MORGAN AND MORECAMBE OFFSHORE WIND FARMS: TRANSMISSION ASSETS

Applicants' Response to Examining Authority's Written Questions (ExQ1)

Document Numbers:
MRCNS-J3303-JVW-19108
MOR001-FLO-CON-CAG-RPT-0092

Document Reference: S_D3_3
F01

Figure 1 – Typical Project Joint Bay and Link Box

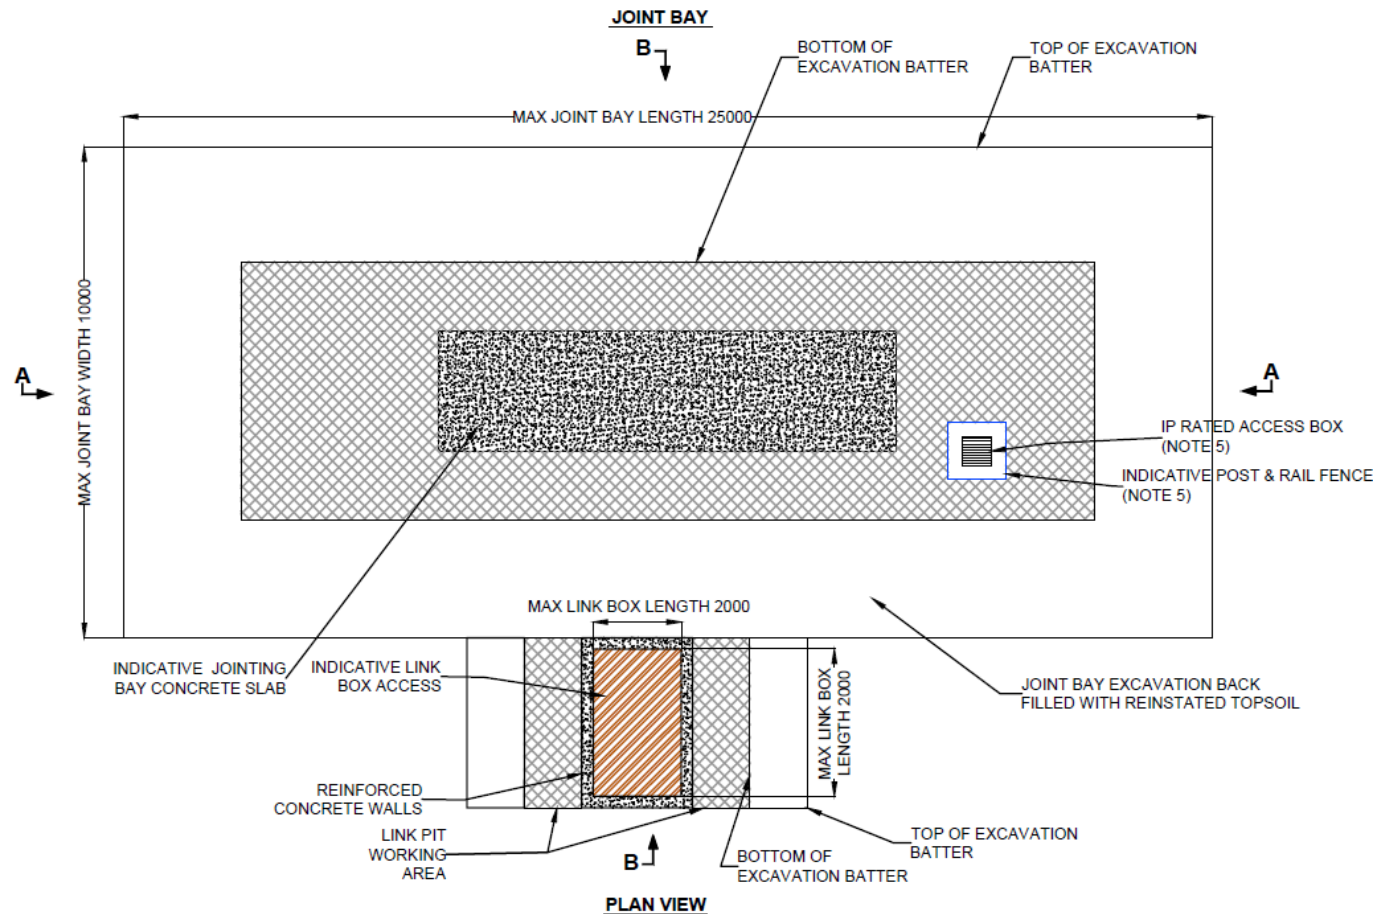
3.1 Response to Q12.1.12(b)
